## Cannondale Motorsports Parts Bulletin

BULLETIN : PB02-002

MODELS : All 2002 ATVs and Motorcycles

SUBJECT : Revised throttle body assembly - bellcrank

**Revised throttle body assembly**

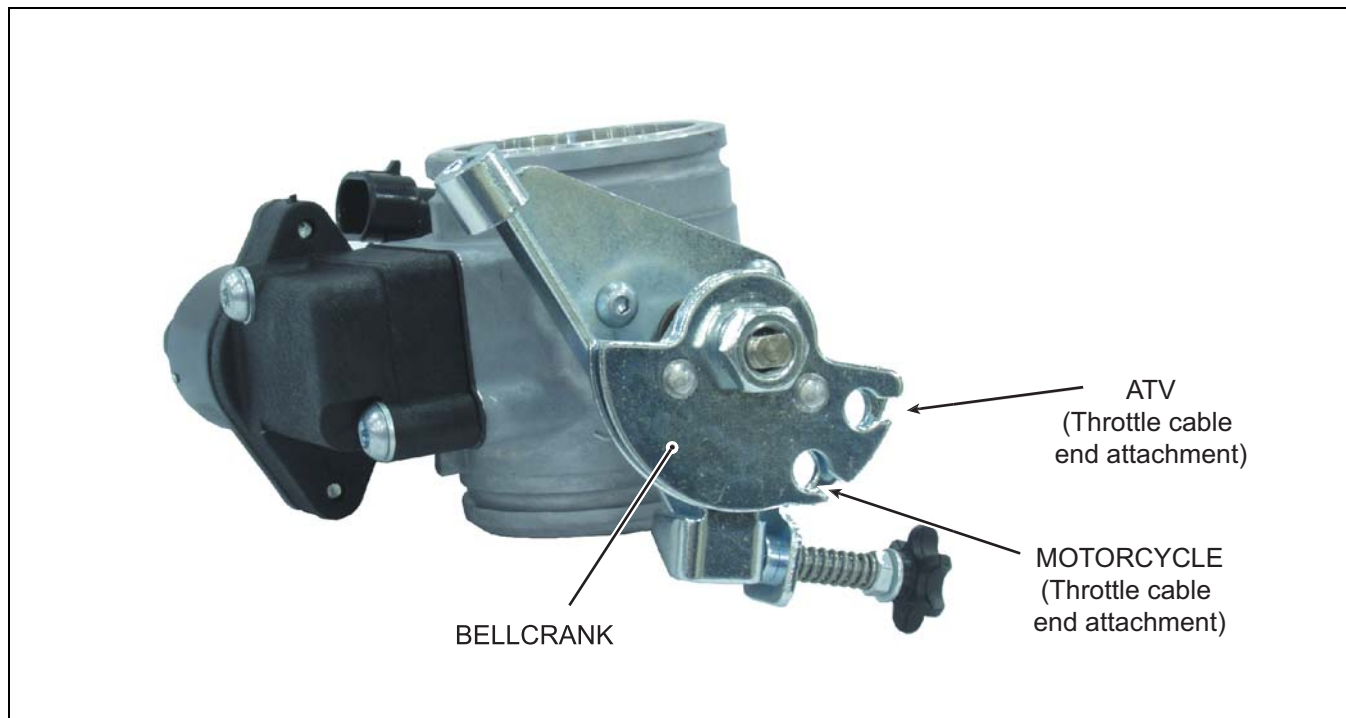
DETAIL : A running change has been made to the throttle body assembly for all 2002 model ATVs and motorcycles. The bellcrank of the revised assembly includes both an ATV and a motorcycle throttle cable end attachment point. To obtain the specified throttle cable freeplay, the cable ends of ATVs and motorcycles must be attached as indicated in the illustration below.

*The revised throttle body assembly includes other component part changes. Consult vehicle parts catalogs.*
